Meeting Minutes

Subject: Technical Team Meeting #9	
Client: CDOT Region 1	
Project: I-70 Peak Period Shoulder Lane	Project No:
Meeting Date: January 27, 2014	Meeting Location: CDOT Golden
Notes by: Lorena Jones	
ATTENDEES: See attached sign-in sheet	t

Existing Conditions

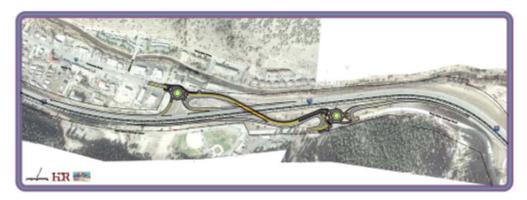
- a. Talked initially about lowering I-70. A few concepts:
 - i. Existing Conditions: Concern with ramp moving at high speed; how to access the business; really awkward location, potentially dangerous

T-Interchange Option

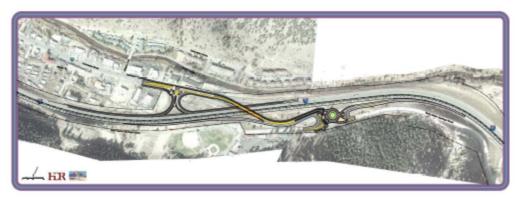
iii. Option 2: T Interchange

iv. What is the timing of 240 and 241 being replaced?

Part of same project, but we do not know of the timing. The 241 interchange will remain open while we work on the 240 interchange. It will be included in our construction phasing to not have both interchanges closed at the same time.
